22 Montague Street, Bloomsbury, London

Section: 07 Appendices

Appendix 02 - Camden Comments EN23/0247

Appendix 03 - IBIS Slate Report July 2023

Photo 2

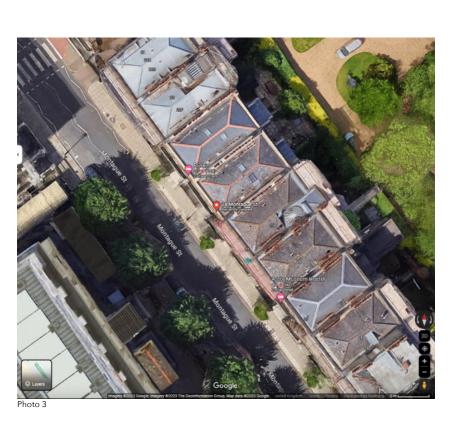
Now look at the attached GoogleEarth image (Photo 3) looking down at the roofs of the area and most are grey, in various shades. There are some that appear to be of a purplish grey colour in locations away from the area but these are few. This image was from September 2022 when the scaffolding was up and the slate very shiny and new and so stands out above and left of centre. Again, the overall suggesting its that the original slates were probably from the Ffestiniog area of Wales.

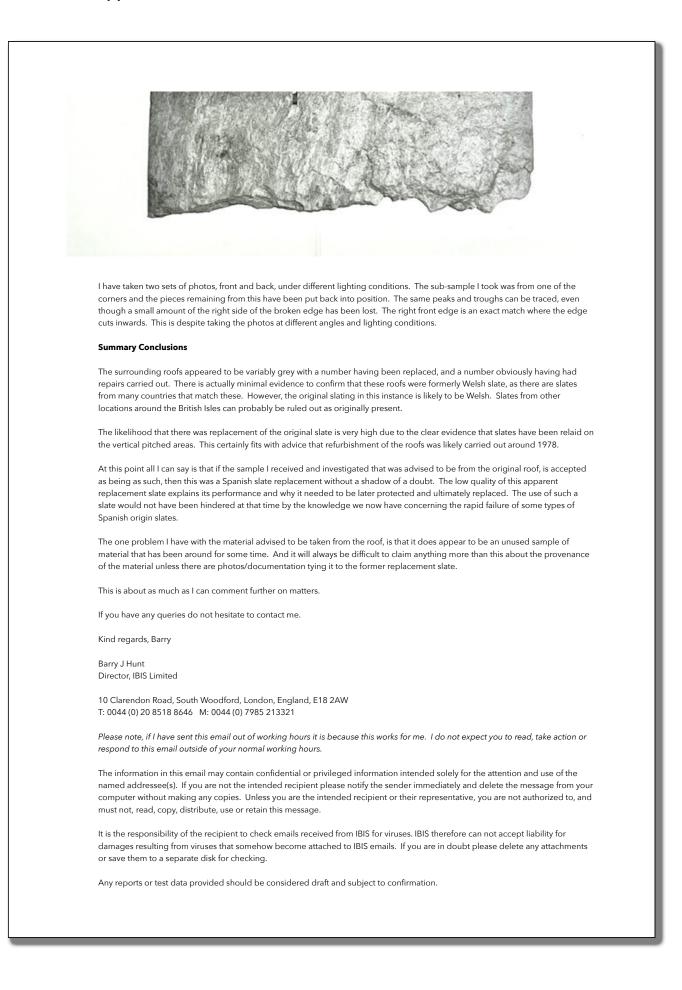
Moving on to the sample advised to have been recovered from the roof prior to the replacement works. The comment that the material I was looking at was not the slate that was said to have been taken from the roof, I can demonstrate that this is clearly incorrect about the sample. Attached are photographs of the slate I looked at and it is clearly the same slate as shown in the report by others. They have failed to grasp that the sample I showed in my photograph was a sub-sample from the slate.

From the images I provide here you can clearly see the exact same broken edge profile and areas where the edge has been eaten away. Some of the slate features are also able to be compared and confirmed to be the same. The problem with the original photograph is it was taken of a partially damp and drying out slate using flash, which is a totally different set of viewing conditions. Those making the comparison have clearly not taken many factors into account. They were lacking in a lot of information, unfortunately.
